AMENDMENT TO FACILITY OPERATING LICENSE

SAFETY EVALUATION BY THE OFFICE OF NUCLEAR REACTOR REGULATION

SUPPORTING AMENDMENT NOS. 70 AND 64

PRAIRIE ISLAND NUCLEAR GENERATING PLANT, UNIT NOS. 1 AND 2

FIGURE TS.6.1-2 PRAIRIE ISLAND NUCLEAR GENERATING PLANT FUNCTIONAL ORGANIZATION FOR ON-SITE GROUP

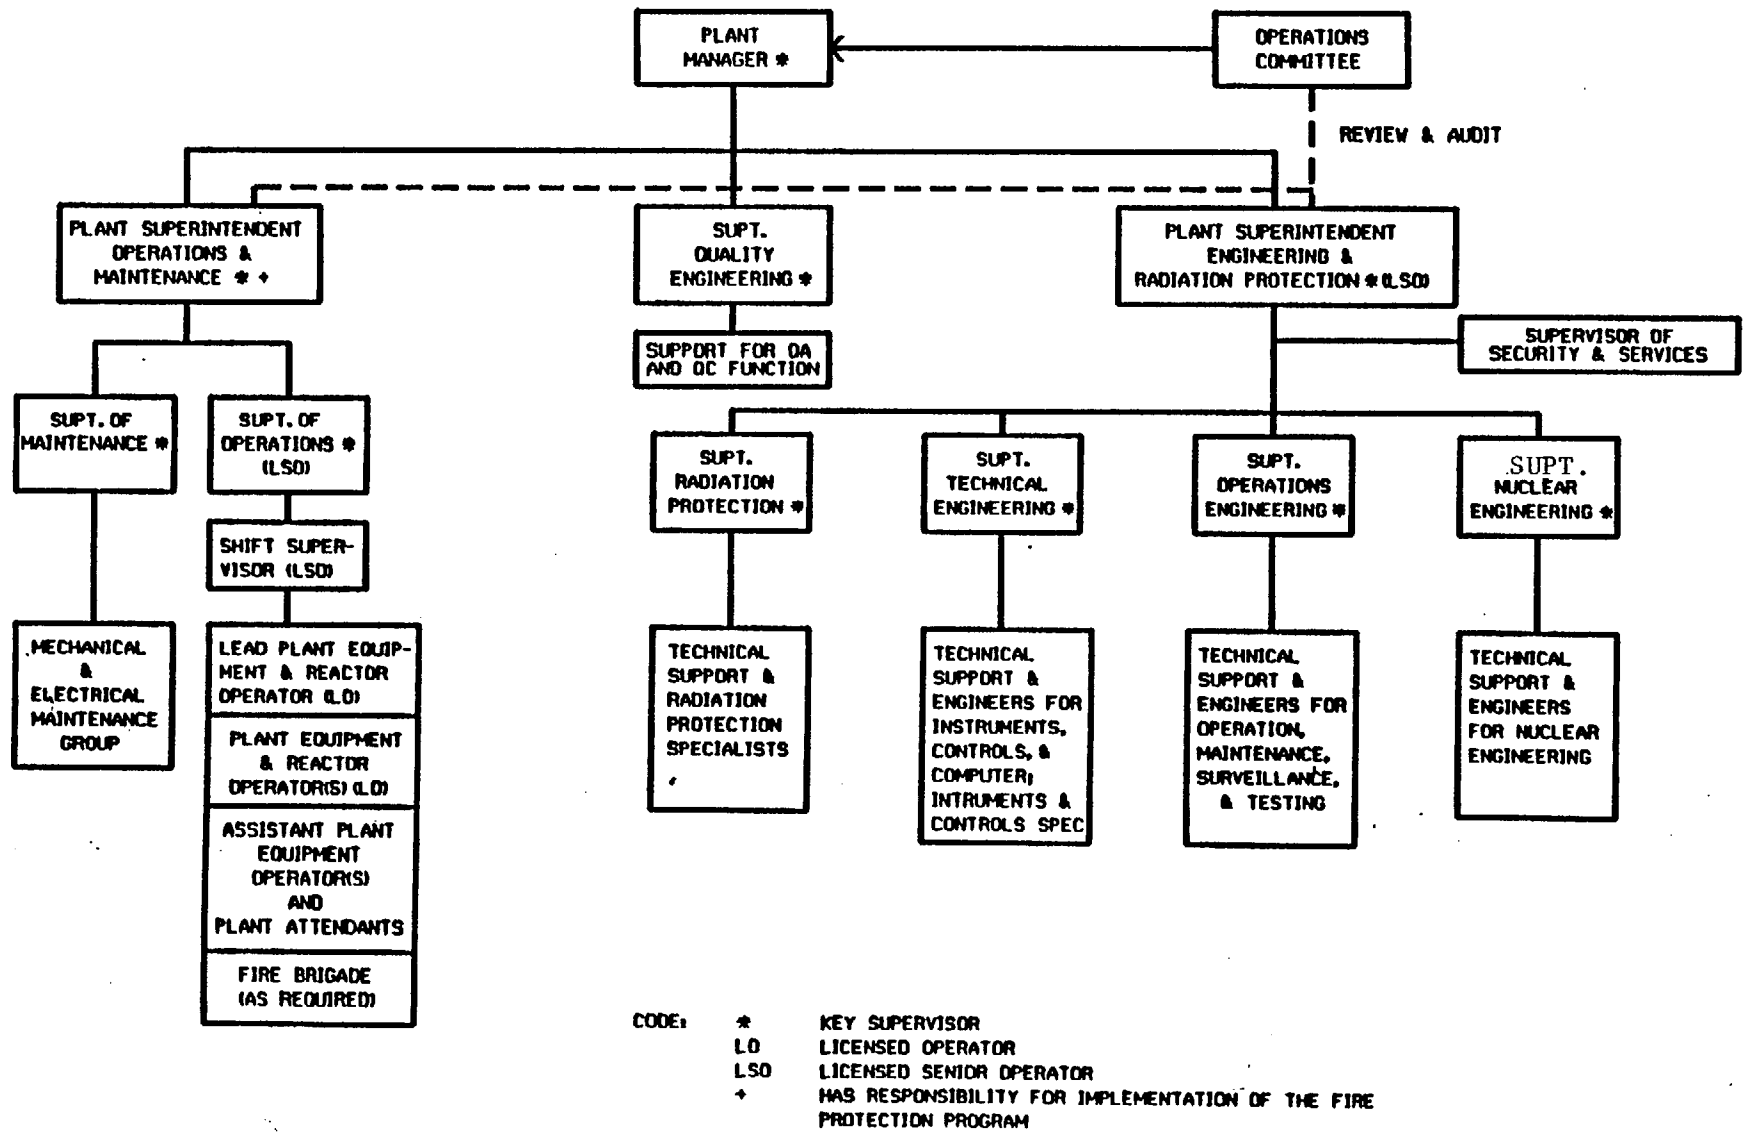
3. TS.4.10 - Radiation Environmental Monitoring Program - Delete Figures TS.4.10-1 and TS.4.10-2.
4. TS.6.1 - Administrative Controls Organization - Change the title of the Nuclear Engineering department head from Senior Nuclear Engineer to Superintendent Nuclear Engineering appearing in the plant organization chart of the technical specification (Figure TS.6.1-2).

The licensee proposed to change the title from "Senior Nuclear Engineering" to "Superintendent Nuclear Engineering" in the title block of TS Figure TS.6.1-2. The title change would make the title appearing in the TS figure agree with the title existing in the actual plant organization. This change is administrative in nature and has no effect on the management function, the

authority or the responsibility of the position identified in the figure. On this basis, the staff concludes that the change will not reduce the level of the plant safety and therefore is acceptable.
